Subject: Dresden Unit 3 Supplement A to Proposed  
 Technical Specification Changes Associated with  
 Second Reload - AEC Dkt 50-249

## SUPPLEMENTAL INFORMATION TO THE DRESDEN 3 SECOND RELOAD LICENSE SUBMITTAL

FIGURE 1 DRESSON 3 CYCLE 3 DESIGN REFERENCE CORE LOADING  
(68 New Bundles)

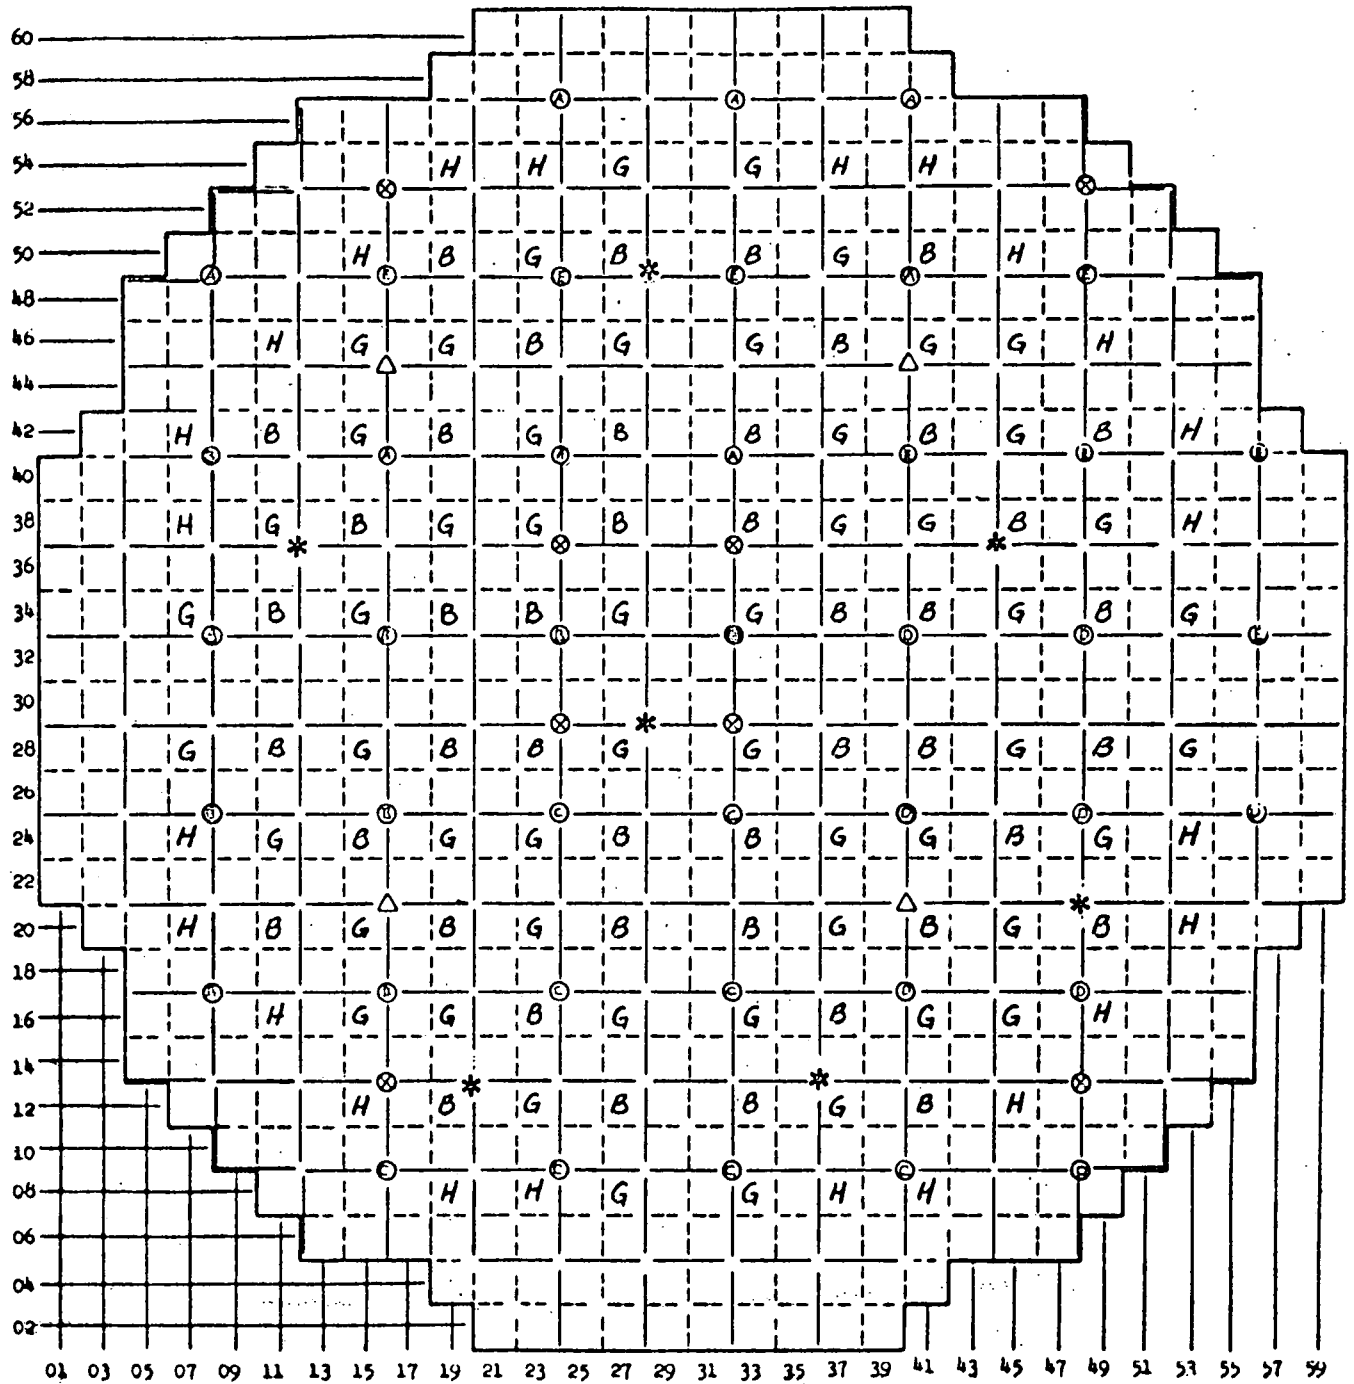
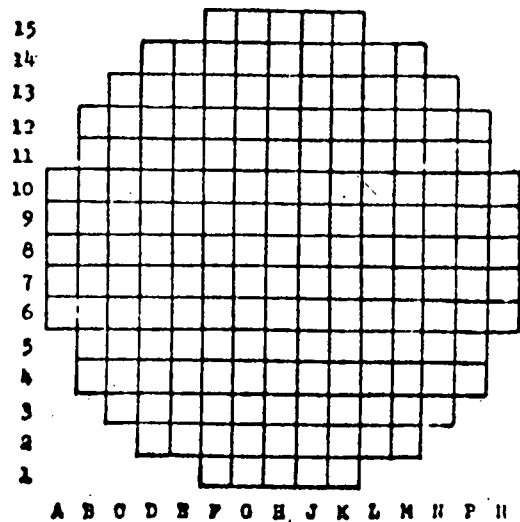
The Dresden 3 reference loading plan for Cycle 3 specified the insertion of up to 60 8x8 2.50  $\bar{e}$  assemblies into the core.<sup>(1)</sup> The reference loading plan in this supplement provides for the loading of up to 68 assemblies consisting of 44 8x8 2.50  $\bar{e}$  assemblies (R2 Type A), and 24 7x7 2.30  $\bar{e}$  assemblies (R2 Type B). The 8x8 fuel is as previously specified<sup>(1)</sup>, and the 7x7 fuel is identical in design to the previously loaded Reload-1 fuel bundle.<sup>(2)</sup> The new design reference core configuration consists of the bundles defined in Table 1 . The relative locations of the 68 assemblies are shown in Figure 1 .

The nuclear characteristics of the core reconstituted with 68 Reload 2 assemblies have been recalculated, and have been found to be as previously reported.<sup>(1)</sup> This is due to the relatively small change in the original loading plan; sixteen 8x8 assemblies replaced with less reactive 7x7 assemblies, and 8 initial core bundles replaced with 7x7 reload assemblies out of a total of 724 bundles in the core.
